**2021 I&M IRP Website Stakeholder Comment Summary**

Stakeholder	Topic	Comment	I&M Response
<b>CAC and Earth Justice submitted comments on Friday, March 26, 2021 7:39 PM; for tracking purposes Day 1 of the 15 working day clock begins on MARCH 29<sup>TH</sup>. The comments are due on April 16.</b>

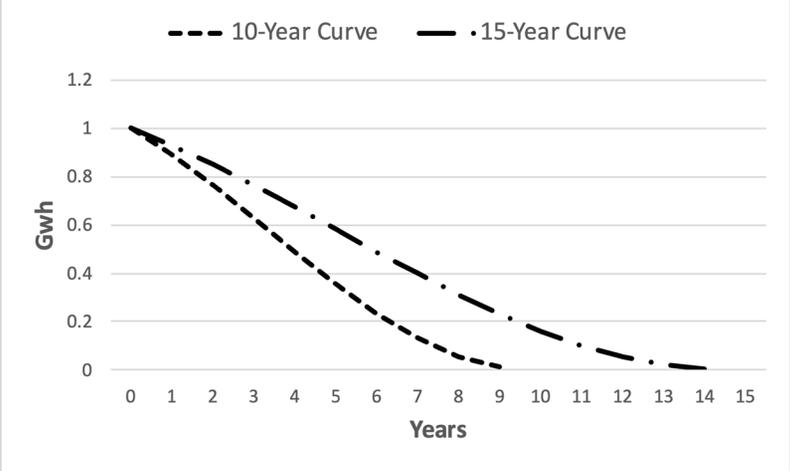
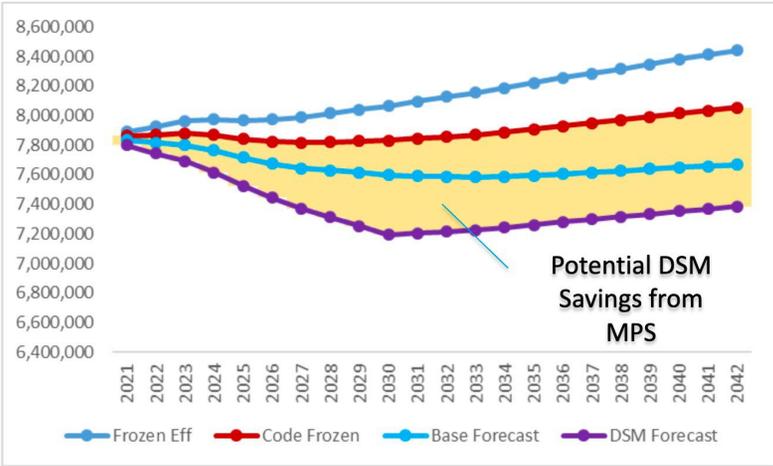
23.	<p>Anna Sommer – Energy Futures Group April 14, 2021 8:26 PM; 4/15/21 for business purposes</p>	<p>G, T, and D modeling</p>	<p>I also wanted to follow up with my question for Bob and Carlos. We were part of a team that recently wrapped up a study looking at meeting up to 75% of Puerto Rico’s energy needs from rooftop solar and battery storage. For that work our team did nodal simulations in Plexos, grid stability analysis in PSS/E, and distribution modeling using OpenDSS. So we can directly relate to the challenge of aligning these functions across different platforms that you were all describing.</p> <p>I had two big takeaways from that work that I think apply to the discussion today. First, it’s really not tractable to perform G, T, and D modeling together with a lot of frequency. There is so much iteration</p>	<p>In response to the first comment related to the frequency of performing G, T and D planning together, we would agree that it can be highly iterative and complex, and therefore requires a tenor reflective of the nature of the work involved. What will be important is that all three processes have the same set of goals and objectives. Establishing this up front will influence what happens in each of the planning processes. The conceptual example described in the question highlights this need for a common set of goals and objectives. When the non-wires</p>

Stakeholder	Topic	Comment	I&M Response
			<p>that takes a lot of time. Second, we saw some counterintuitive results in our study, particularly as it relates to the distribution system. A relatively modest number of mitigations were needed on the distribution system to achieve 75% solar/storage penetration. This was in part because those systems were spread out across lines rather than concentrated. And so I wonder if what I&amp;M might aim for, likely in the next IRP, is to bookend a heavy buildout of DERs throughout its distribution system but particularly on all lines that are or are likely to become overloaded? It seems like the main way we can get distribution planning results to interface with generation planning (for the moment) is if we can better evaluate and isolate the deferral benefit of DERs. And I worry that doing this on a piecemeal basis as is typically done in non-wires alternatives analysis leaves much to be desired in terms of optimizing the total value of DERs. I realize that is a super conceptual suggestion, but it also seems like having an analytical goal to aim for is the only way to start doing this work and figure out how to align these planning processes. So I'd be interested to hear what Bob and Carlos think about that?</p>	<p>alternatives analysis is approached from the perspective of distribution planning, it is done with the objective to resolve an emerging need on the distribution system more so than trying to address a more holistic concern that might involve G and T. If the perspective is changed to where the need is more broadly defined to include G and T requirements, then the analysis, solutions and economics all begin to look very different. This is the perspective the newly formed Grid Solutions organization is expected to bring to our planning efforts going forward – a holistic view of our customers’ and/or system’s needs and an array of solutions to best address those needs.</p> <p>Relative to the specific analytics being described in the question, there are likely steps we could take in the short-term. For example, distribution station transformers or feeder exits out of substations may be an area where we could focus our initial efforts. We would need to spend some time working out criteria, assumptions, assessment of benefits and costs and process details that don’t exist today. For example, developing a set of assumptions around the type/sizing/performance expectations of the DERs would be extremely important. In addition, our planning criteria will need to be enhanced to be more inclusive of the types of solutions we would deploy and when and how we would deploy them. There are other challenges we would need to address, especially if we want to take this type of analysis to the broader reaches of the distribution system, including more detailed load forecasting, enhanced information technology to drive process efficiencies given the potential volume of work,</p>

2021 I&M IRP Website Stakeholder Comment Summary				
	Stakeholder	Topic	Comment	I&M Response
				and the new tools and analytics required to develop solutions.  All that said, this is a great aspirational goal to put in front of us and we agree that having the goal is a necessary requirement if we ever hope to get there.
